PREPARED FOR THE PLAN COMMISSION

Project Address: 223 South Pinckney Street (District 4- Ald. Verveer)
Application Type: Demolition Permit, Planned Development Alteration, Conditional Use, and Certified Survey Map
Legistar File ID # [55916](#), [55921](#), [56121](#), & [56288](#)
Prepared By: Kevin Firchow, AICP, Planning Division
Report includes comments from other City agencies, as noted
Reviewed By: Heather Stouder, AICP, Planning Division Director

Requested Action: The applicants request approval of the following: 1) Zoning Map Amendment to approve a revised Specific Implementation Plan; 2) Conditional Use (re-approval) for elevator / mechanical equipment above the Capitol Height Limit; 3) Demolition Permit (re-approval) for the Government East Parking Garage, and 4) Two-lot Certified Survey Map (CSM).

Above: West Wilson Street - Lower Levels of Hotel
Proposed May 7, 2019 Alteration

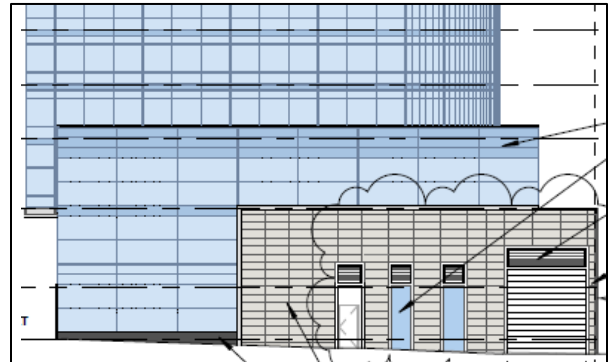
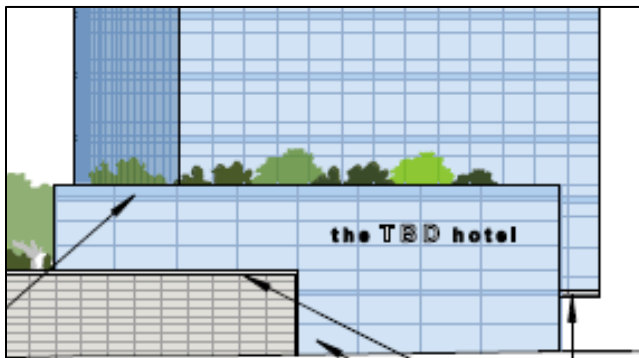
Corresponding façade changes are proposed to the East Wilson and Doty Street facades. Along Wilson Street, the previously approved underground parking entrance is now comprised of a door and spandrel-clad panels. Along Doty Street, additional windows and doors to an enclosed bike parking area are now proposed. No changes are proposed along South Pinckney Street.
